# Access Compliance Report

## Public Rights-of-Way

Intersection ID: 13568	Main Street: ARLINGTON_AV	Cross Street: SOUTH_BV	Location:	N
ADA ID: C5965DF922D7	Ramp Type: Perp	Initial Pass/Fail: Fail	Overall Compliance: No	Severity Score: 1.25

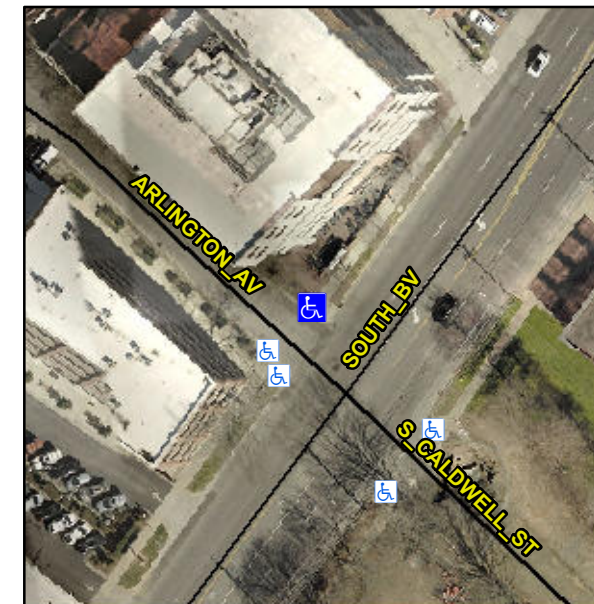
**Not Found, R304.5.3**

Compliance	Description	Data	Compliance	Description	Data
N/A	Ramp Length (in)	111.0	Yes	Ramp Slope (%)	5.3
Yes	Ramp Width (in)	69.0	No	Ramp XSlope (%)	2.6
N/A	Flare Type LT	N/A	N/A	Flare Type RT	N/A
N/A	Flare Slope LT (%)	N/A	N/A	Flare Slope RT (%)	N/A
N/A	Flare Traversable LT?	N/A	N/A	Flare Traversable RT?	N/A
N/A	Landing Length (in)	N/A	N/A	DWS Provided?	N/A
N/A	Landing Width (in)	N/A	N/A	DWS Contrast?	N/A
N/A	Landing Slope (%)	N/A	N/A	DWS Length (in)	N/A
N/A	Landing X Slope (%)	N/A	N/A	DWS Full Width?	N/A
N/A	Landing Curb? (Y/N)	N/A	N/A	DWS Offset (in)	N/A
N/A	Shared Landing?	N/A			
N/A	Gutter Ponding?	N/A	N/A	Gutter Slope (%)	N/A
N/A	Gutter Lip Ht (in)	N/A	N/A	Gutter X Slope (%)	N/A
N/A	Painted X Walk1?	No	N/A	Painted X Walk2?	N/A
	X Walk 1 Direction	To SW		X Walk 2 Direction	N/A
N/A	X Walk 1 Width (in)	N/A	N/A	X Walk 2 Width (in)	N/A
	X Walk 1 Slope (%)	2.2		X Walk 2 Slope (%)	N/A
	X Walk 1 X Slope (%)	0.7		X Walk 2 X Slope (%)	N/A

**Remove & Replace Entire Ramp.**
